# Bloodmill Rd Extension Limerick

## Stage 1 Road Safety Audit

July 2023

| <b>Document Title</b> | Report for Stage 1 – Road Safety Audit                            |

Fig 2.1

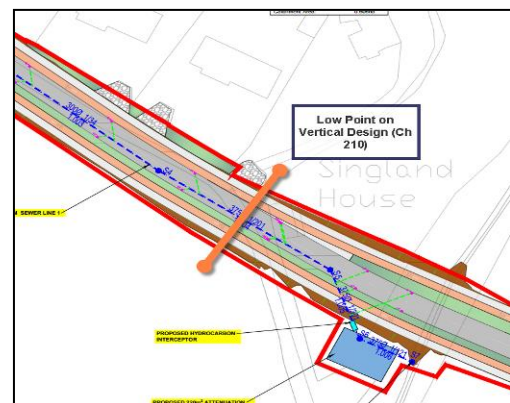
The audit team noted that the storm drainage design has been carried out but the location of road gullies should be reviewed. No road surface water Gullies appear to be shown at the lowest vertical point on the road Lack of road surface drainage could lead to surface water ponding and could lead to collisions between vehicles or vehicles and pedestrians due to aquaplaning on water ponds following periods of heavy rainfall. Ref to Fig 2.1

Provide adequate road surface water drainage along the length of the scheme.

| Paragraph No. in Safety Audit Report | To be completed by the Designer |                                       |  | To be Completed by Audit Team Leader                          |
|--------------------------------------|---------------------------------|---------------------------------------|--|---|
| 2.2                                  | Yes                             | Yes                                   |  |   |

The drawings provided to the audit team, do not show the proposed junction radii at the junction of Bloodmill Rd and Amharc Muileann. Failure to provide adequate junction radii could lead to vehicles existing and entering the development at an excessive speed. Large junction radii also increase the distances for pedestrians to cross the junction and may lead to collision between pedestrians and vehicles entering and exiting. Refer to Fig 2.1 & 2.2

Ensure that adequate junction radii are provided at the junction of Bloodmill Rd and Amharc Muileann.

| Paragraph No. in Safety Audit Report | To be completed by the Designer |                                       |  | To be Completed by Audit Team Leader                          |
|--------------------------------------|---------------------------------|---------------------------------------|--|---|
| 2.4                                  | Yes                             | Yes                                   | Junction radii will be reduced to 6m   |   |

Fig 2.2

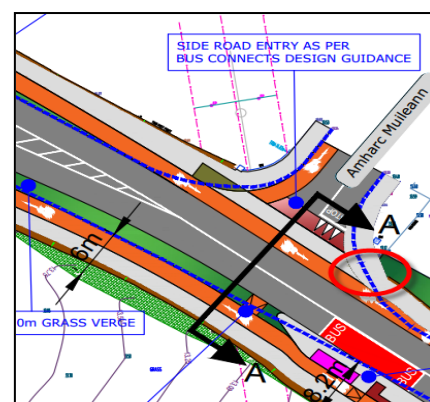
The drawing issued to the audit team, does not appear to show tactile paving on the eastern side of the uncontrolled pedestrian crossing at the entrance to Amharc Muileann. Failure to provide the appropriate tactile paving at pedestrian crossing may lead to confusions around priority at the crossing. This could lead to collisions between vehicle drivers and vulnerable road users.

The design team should review the use of Tactile Paving on both sides of this junction.

| Paragraph No. in Safety Audit Report | To be completed by the Designer |                                       |  | To be Completed by Audit Team Leader                          |
|--------------------------------------|---------------------------------|---------------------------------------|--|---|
| 2.3                                  | Yes                             | Yes                                   |  |   |

**Fig 2.3**

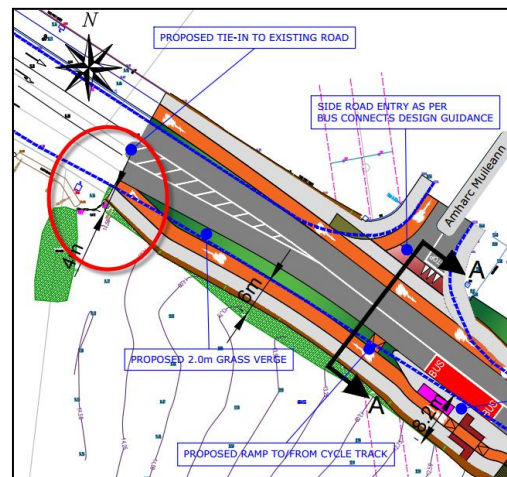
The drawings submitted for audit don't show how cyclist will exit the proposed cycle track to Bloodmill Rd at the western extents of the scheme. This could lead to potential collisions between cyclists and vehicles travelling on Bloodmill Rd. Refer to Figure 2.3 which shows the Western end of the Cycle Track

The proposed access/egress points for cyclists' should be clarified/reviewed to minimise the interaction between vulnerable road users and vehicles

| Paragraph No. in Safety Audit Report | To be completed by the Designer |                                       |  | To be Completed by Audit Team Leader                          |
|--------------------------------------|---------------------------------|---------------------------------------|--|---|
| 2.5                                  | Yes                             | Yes                                   | Cycle track transition to carriageway to be re-designed  |   |

**Fig 2.4**

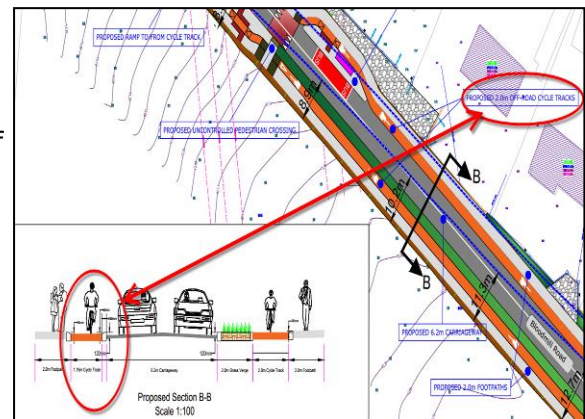
The drawings submitted for audit appear to show a discrepancy in the width of the Cycle Track on the Northern side of Bloodmill Rd. The Plan view shows a width of 2.0m and the cross section a width of 1.75m. Refer to Figure 2.4

The design team should provide clarity as to the proposed cycle track width.

| Paragraph No. in Safety Audit Report | To be completed by the Designer |                                       |  | To be Completed by Audit Team Leader                          |
|--------------------------------------|---------------------------------|---------------------------------------|--|---|
| 2.6                                  | Yes                             | Yes                                   | Cycle track width to be clarified on all drawings  |   |
